Docket Item #6
SUBDIVISION #2005-0008

Planning Commission Meeting
November 1, 2005

ISSUE: Consideration of a request to subdivide the subject property into two lots.

LOCATION: 30 Sunset Drive

Plan A

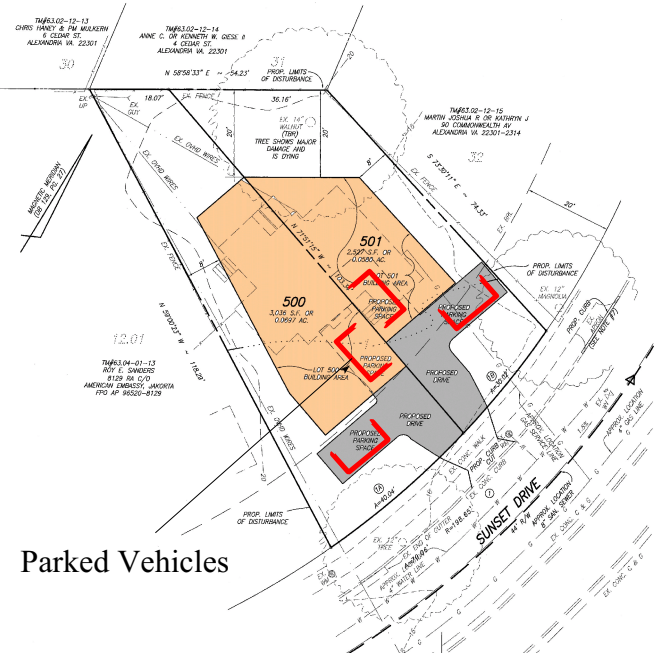
The applicant has not submitted an application for a curb cut. However, at staff’s request, the applicant provided a conceptual parking and curb cut scheme as part of the subdivision application (shown here as Plan A). After reviewing the plan, staff found that it was not acceptable, both from a safety and design perspective. The location and configuration of the two driveways on the inside portion of a curve located in close proximity to the intersection of Commonwealth Avenue has poor sight distance which results in a hazardous condition for vehicles backing out onto the street. Staff found that the location and nature of the proposed curb cut and associated parking did not conform with the character and architectural style of the developed block face. Staff met with the applicant to discuss its concerns.

- F-1 T&ES does not support separate driveways for each of the properties as illustrated on the plan [*Plan A*] because the location and configuration of two driveways on the inside portion of a curve located in close proximity to the intersection of Commonwealth Avenue has poor sight distance which results in a hazardous condition for vehicles backing out onto the street.

- R-1 The proposed subdivided properties shall be served by joint access with a single driveway entrance not to exceed 16 feet in width. Provision for an on-site turnaround shall be provided to the satisfaction of the Director of T&ES.
Note: Staff did not include this condition because it does not address staff's concern about compatibility with the developed block face, and limits consideration of a parking reduction application. Instead, staff has included a condition that the applicant "submit an application for any proposed curb cut for approval by the Directors of Planning and Zoning and Transportation and Environmental Services, and/or an application for Special Use Permit for a parking reduction."

Plan B

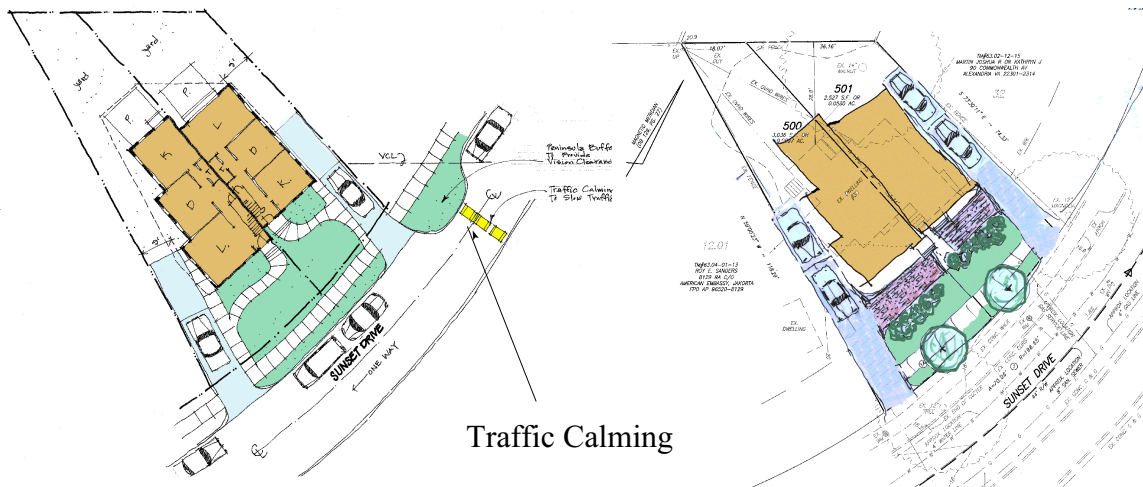
The applicant provided a subsequent scheme (pictured here as Plan B). The proposal included a single 16-foot wide curb cut for both properties, and front loaded garages and surface parking in the front yard, resulting in a great deal of paving in the front yards of the proposed semi-detached dwellings. The plan depicted the T&ES recommendation that, “The proposed subdivided properties shall be served by joint access with a single driveway entrance not to exceed 16 feet in width. Provision for an on-site turnaround shall be provided to the satisfaction of the Director of T&ES.” Although the plan creates a safe condition for this difficult road segment, it is one that is drastically out of character with the street and neighborhood.
